Consideration of lower level apartments

1 Details of the proposed lower level apartments and discussion

Figure 1: Extract from the Overall Ground Lower Plan, Drawing No. TP01.02, identifying the location of the apartments which are below their adjoining public domain or internal courtyard levels.

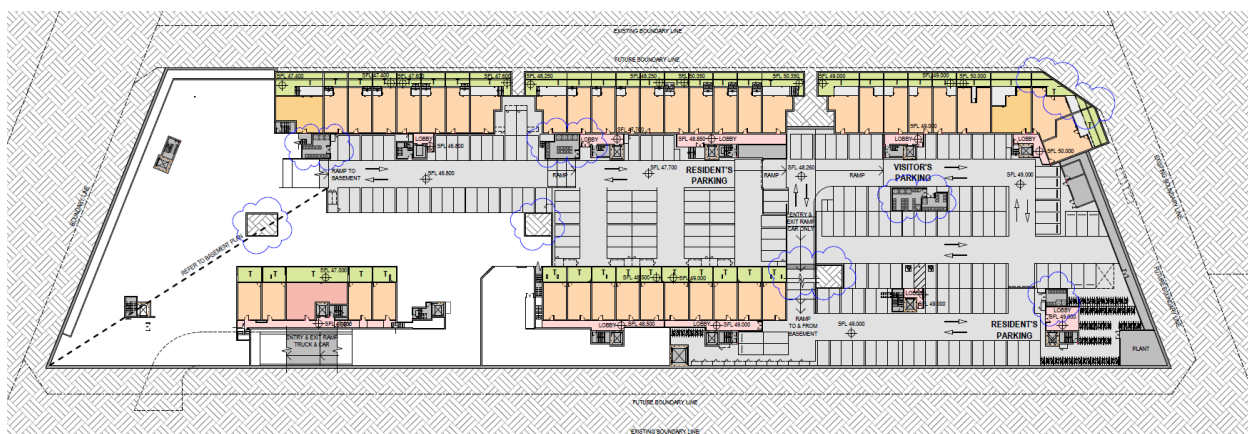
- 1.1 The proposal comprises 42 apartments which have a split level design, with their lower level below the adjoining ground levels. This includes 27 apartments along the northern side of Buildings B, C and D which have lower levels and courtyards which are up to 3 m below the new public domain level. This is 8 % of the total apartments. Direct access is provided from the public domain level via an access bridge to each apartment. 15 apartments within Buildings E and F which are located adjoining the internal courtyards also have lower levels and courtyards which are up to 1.5 m below the new communal courtyard level. This is 5 % of the total apartments. The location of these apartments is shown in Figure 1 below.

- 1.4 Our City Architect has reviewed the application in detail and advises that apartments below ground are typically not supported, however the design of the apartments that are below ground in this development are a specific response to the site constraints and supported for the following reasons:

- a. The overall proposal is well designed
 - b. The double height unit solution has been well conceived – the units are only proposed where they face north to ensure sun access

- c. Its inclusion gives amenity benefits, otherwise unattainable (see below)
 - d. Privacy is easily managed (as for ground floor units you would use blinds)

- e. The courtyards created are more secure and private than ground level courtyards.
- 1.5 The benefit of this overall design is that its basement waste collection solution is better than any other proposal we have seen. It achieves this by shifting what would otherwise be ground level units to replace them with basement ramps within the building envelope. The lost floor area is compensated in the lower level of the two level units. As a consequence the proposal maximises communal open space without having it compromised by a large cut in the site to accommodate a vehicle ramp.

- 1.7 It is also noted that the 15 split level apartments within Buildings E and F feature a lower level courtyard which is only up to 1.5 m below the new communal courtyard level, and does not impact on the appearance and the activation of the public domain.

- 1.9 Although the proposed lower level apartments are inconsistent with the direction of Part 3C Public Domain interface of the Apartment Design Guide (ADG), which provides direction for the relationship between levels and the scenarios between apartments and the public domain, we consider this to be a carefully considered design approach which is supported in this instance.

Figure 2: Extract from Section 3 Design Evolution and response from the Architect's Design Report dated December 2016 demonstrating the design intention of the proposed courtyards.

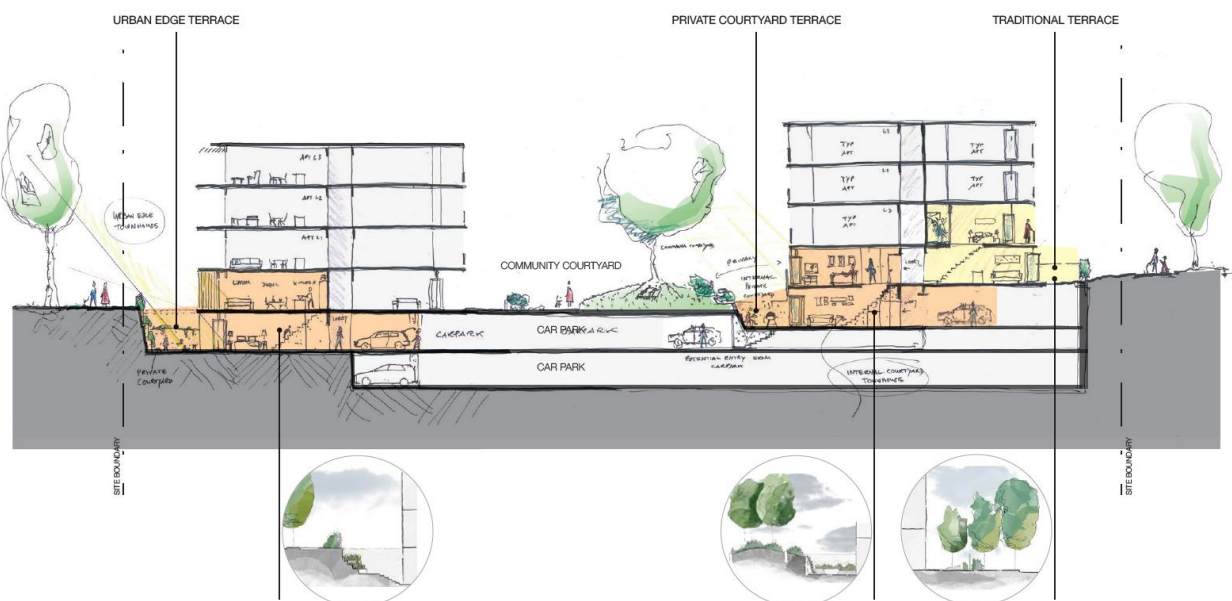
- 1.2 The architect's statement submitted in support of this application provides justification for the proposal, and states that the proposal comprises two new typologies as a new suburban way of living, being an urban edge terrace and a private courtyard terrace, in addition to the standard traditional terrace. These forms are demonstrated in the section plan in Figure 2 below.
